**APPENDIX E:**  
VISUAL SIMULATIONS

**VISUAL CONTRAST RATING WORKSHEET**

<p><b>1. Project Name</b> Nine Mile Canyon, West Tavaputs BBC</p> <p><b>2. Key Observation Point</b> Nine Mile Canyon Corridor 1, KOP 1, Alternative A-exist. alignment expansion</p> <p><b>3. VRM Class</b> Class II</p>	<p><b>4. Location</b></p> <p>Township <u>12 S</u></p> <p>Range <u>16 E</u></p> <p>Section <u>9</u></p>	<p><b>5. Location Sketch</b></p>
---	--	----------------------------------

<b>1. Project Name</b> Nine Mile Canyon, West Tavaputs BBC	<b>4. Location</b> Township <u>12 S</u> Range <u>16 E</u> Section <u>9</u>	<b>5. Location Sketch</b> 
<b>2. Key Observation Point</b> Nine Mile Canyon Corridor 1, KOP 1, Alternative C - realignment expansion		
<b>3. VRM Class</b> Class II

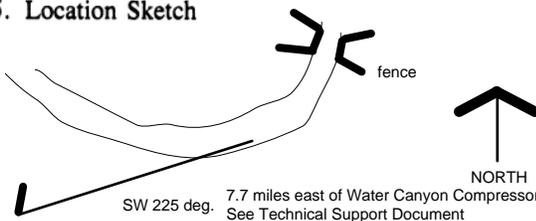
1. LAND/WATER	2. VEGETATION	3. STRUCTURES
<b>FORM</b>	no change	no change	16" round cylindrical pipe running down slope face; larger
<b>LINE</b>	no change	no change	45 deg. at top; 's' curve with varying angles at bottom (disappears and reappears behind ridge)
<b>COLOR</b>	no change	no change	dark brown to rust color; painted with non- reflective paint
<b>TEXTURE</b>	no change	no change	smooth

<b>1. DEGREE OF CONTRAST</b>	<b>FEATURES</b>												<b>2. Does project design meet visual resource management objectives?</b> <input checked="" type="checkbox"/> <b>Yes</b> <input type="checkbox"/> <b>No</b> (Explain on reverse side)
	<b>LAND/WATER BODY (1)</b>				<b>VEGETATION (2)</b>				<b>STRUCTURES (3)</b>				
	Strong	Moderate	Weak	None	Strong	Moderate	Weak	None	Strong	Moderate	Weak	None	<b>3. Additional mitigating measures recommended</b> <input checked="" type="checkbox"/> <b>Yes</b> <input type="checkbox"/> <b>No</b> this is the revised alignment alt - pipeline behind ridge see below
<b>ELEMENTS</b>													
Form				/				/				/	
Line				/				/				/	
Color				/				/				/	
Texture				/				/				/	
<b>Evaluator's Names</b>													-use non reflective paint -paint to match landscape -'s' curves at bottom should follow contours -add shrubs to break up 'line' and 'texture' of pipe

<b>1. Project Name</b> Nine Mile Canyon, West Tavaputs BBC	<b>4. Location</b> Township <u>12 S</u> Range <u>15 E</u> Section _____	<b>5. Location Sketch</b> 
<b>2. Key Observation Point</b> Dry Canyon Corridor 2, KOP 4, Alternative A- unburned surface expansion		
<b>3. VRM Class</b> Class II

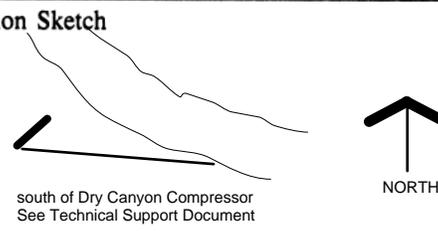
1. LAND/WATER	2. VEGETATION	3. STRUCTURES
<b>FORM</b>	no change	no change	Larger rounded, cylindrical form. More prominent tubelike structure extending from immediate foreground into far foreground.
<b>LINE</b>	no change	no change	Bold, definitive, slightly curving into view. Becomes discontinuous and broken as it extends into vegetation.
<b>COLOR</b>	no change	no change	Depends on time of day, angle and direction of light. Brown to reddish brown. light to dark value indicating form. Highlights and shadows increase visibility. Monotone.
<b>TEXTURE</b>	no change	no change	Smooth and matte. Very uniform texture across entire structure, where visible.

<b>ELEMENTS</b>	<b>1. DEGREE OF CONTRAST</b>	<b>FEATURES</b>												<b>2. Does project design meet visual resource management objectives?</b> <input checked="" type="checkbox"/> Yes <input type="checkbox"/> No (Explain on reverse side)
		<b>LAND/WATER BODY (1)</b>				<b>VEGETATION (2)</b>				<b>STRUCTURES (3)</b>				<b>3. Additional mitigating measures recommended</b> <input checked="" type="checkbox"/> Yes <input type="checkbox"/> No see below
		Strong	Moderate	Weak	None	Strong	Moderate	Weak	None	Strong	Moderate	Weak	None	
	Form			/				/				/		
	Line			/				/				/		
Color			/				/				/			
Texture			/				/				/			
<b>Evaluator's Names</b> K. Kvarfordt J. Ellsworth April 08, 2004 -screen pipe where possible with additional shrubs and tubelings

<b>1. Project Name</b> Nine Mile Canyon, West Tavaputs BBC	<b>4. Location</b> Township <u>12 S</u> Range <u>15 E</u> Section <u>12</u>	<b>5. Location Sketch</b> 
<b>2. Key Observation Point</b> Nine Mile Canyon Corridor 3, KOP 1, Alternative C - Buried pipe		
<b>3. VRM Class</b> Class II

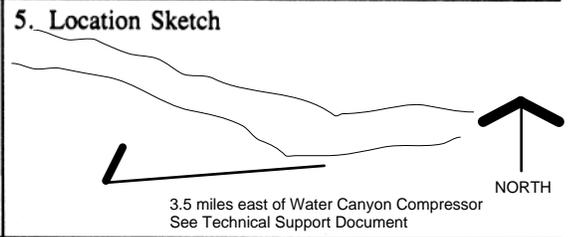
1. LAND/WATER	2. VEGETATION	3. STRUCTURES
<b>FORM</b>	Flat extending across majority of view, not much change from existing character. Much larger form apparent in foreground and extending into middle ground of view.	Major vegetative forms are rounded clumps, scattered along sides of disturbed area. Major vegetative form removed.	No structure present in view.
<b>LINE</b>	Soft lines defining road embankment are more prominent.	Vegetative edges converging into distance along area of disturbance are the most prominent. Line is soft but definitive.	No structure present in view.
<b>COLOR</b>	More light tan to nearly white visible where disturbance has occurred.	Much more yellow and grayish green. Reddish gray masses still present, but less prominent in view. Light to dark defines forms.	No structure present in view.
<b>TEX-TURE</b>	Much more fine to medium texture due to increased exposure.	Fine grass texture in foreground increased and continues into middleground of view. Coarse scattered textures along road embankment are more revealed.	No structure present in view.

<b>1. DEGREE OF CONTRAST</b>	<b>FEATURES</b>												<b>2. Does project design meet visual resource management objectives?</b> <input type="checkbox"/> Yes <input checked="" type="checkbox"/> No (Explain on reverse side)  <b>3. Additional mitigating measures recommended</b> <input checked="" type="checkbox"/> Yes <input type="checkbox"/> No see below
	<b>LAND/WATER BODY (1)</b>				<b>VEGETATION (2)</b>				<b>STRUCTURES (3)</b>				
	Strong	Moderate	Weak	None	Strong	Moderate	Weak	None	Strong	Moderate	Weak	None	
	Form	ST	LT		ST	LT			ST	LT			
	Line	ST	LT		ST	LT			ST	LT			
Color	ST	LT		ST	LT			ST	LT				
Texture	ST	LT		ST	LT			ST	LT				
<b>ELEMENTS</b>	<b>Evaluator's Names</b>												April 03, 2004  -use more accurate trenching techniques to disturb narrower area -feather vegetative edge of impact -produce a revegetation plan to include shrubs -carefully regrade and recontour to approximate original topography

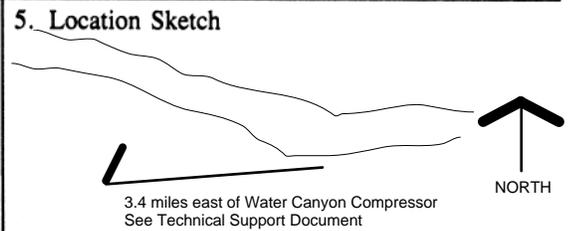
1. LAND/WATER	2. VEGETATION	3. STRUCTURES
<b>FORM</b>	no change	slight variation to some vegetation due to crushing by direct placement of pipe	larger, round cylindrical form; more prominent tubelike structure; primarily foreground
<b>LINE</b>	no change	no change	bold, definitive, slightly curving into foreground view; becomes discontinuous and broken as extends into vegetation
<b>COLOR</b>	no change	no change	depends on time of day, angle and direction of light; brown to reddish brown, light to dark value indicating form; highlights and shadows increase visibility; monotone
<b>TEXTURE</b>	no change	no change	smooth and matte(when new); very uniform texture across entire structure where visible

<b>1. DEGREE OF CONTRAST</b>	<b>FEATURES</b>												<b>2. Does project design meet visual resource management objectives?</b> <input checked="" type="checkbox"/> Yes <input type="checkbox"/> No (Explain on reverse side)
	<b>LAND/WATER BODY (1)</b>				<b>VEGETATION (2)</b>				<b>STRUCTURES (3)</b>				
	Strong	Moderate	Weak	None	Strong	Moderate	Weak	None	Strong	Moderate	Weak	None	<b>3. Additional mitigating measures recommended</b> <input checked="" type="checkbox"/> Yes <input type="checkbox"/> No see below
	<b>ELEMENTS</b>	Form											
Line													
Color													
Texture													
<b>Evaluator's Names</b> K. Kvarfordt J. Ellsworth April 03, 2004													-carefully place pipe to maximize screening by existing vegetation -revegetate where necessary to increase vegetative screening by shrubs especially where existing shrubs are sparse

<b>1. Project Name</b> Nine Mile Canyon, West Tavaputs BBC	<b>4. Location</b> Township 12 S Range 15 E Section 12	<b>5. Location Sketch</b> 
<b>2. Key Observation Point</b> Nine Mile Canyon - Stream Crossing Corridor 3, KOP 2, Alternative C - Buried Pipe		
<b>3. VRM Class</b> Class II

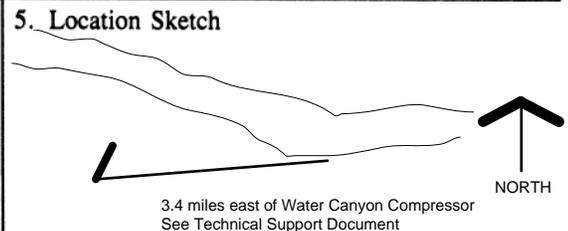
1. LAND/WATER	2. VEGETATION	3. STRUCTURES
<b>FORM</b>	similar to existing assuming will re-contour; stream maybe partially revealed in short term, embankment edge degraded; rounded, sloughed	low (grasses); indistinct corridor edge; limited clumping of shrubs; simple; amorphous	definite; rounded, cylindrical; foreshortened; distinct endpoints
<b>LINE</b>	cut edge of cliff will be gentler slope; exposing more soil and reflecting sun & shadow; more complex edge less bold	edge of corridor strong, bold; diagonal edge in perspective (converging)	diagonal; weak to bold depending on lighting; straight; simple; hard; continuous; parallel
<b>COLOR</b>	no change in color but more due to exposed soil at cut and short term scarcity of vegetation	earth tones; mostly grays and greens in short term; light values; low glare; dull, subtle	earth tones recommended; dull; warm; brownish-tan-reddish; shadows/value change due to cylindrical form; monotone; some highlights

<b>1. DEGREE OF CONTRAST</b>	<b>FEATURES</b>												<b>2. Does project design meet visual resource management objectives?</b> <input type="checkbox"/> Yes <input checked="" type="checkbox"/> No (Explain on reverse side)
	<b>LAND/WATER BODY (1)</b>				<b>VEGETATION (2)</b>				<b>STRUCTURES (3)</b>				
	<b>Strong</b>	<b>Moderate</b>	<b>Weak</b>	<b>None</b>	<b>Strong</b>	<b>Moderate</b>	<b>Weak</b>	<b>None</b>	<b>Strong</b>	<b>Moderate</b>	<b>Weak</b>	<b>None</b>	<b>3. Additional mitigating measures recommended</b> <input checked="" type="checkbox"/> Yes <input type="checkbox"/> No see below
	<b>Form</b>				ST	LT							
<b>Line</b>				ST	LT			ST	LT				
<b>Texture</b>				ST	LT								
<b>ELEMENTS</b>													<b>Evaluator's Names</b> K. Kvarfordt J. Ellsworth April 01, 2004

- reveg to screen pipes with shrubs nearby
- stabilize escarpment, keep equipment away from edge to minimize disturbance
- include fast-growing shrubs in seed mix, tubing
- use trencher to avoid wide disturbance
- feather and vary edge of disturbance and be very selective in vegetation removal on edge
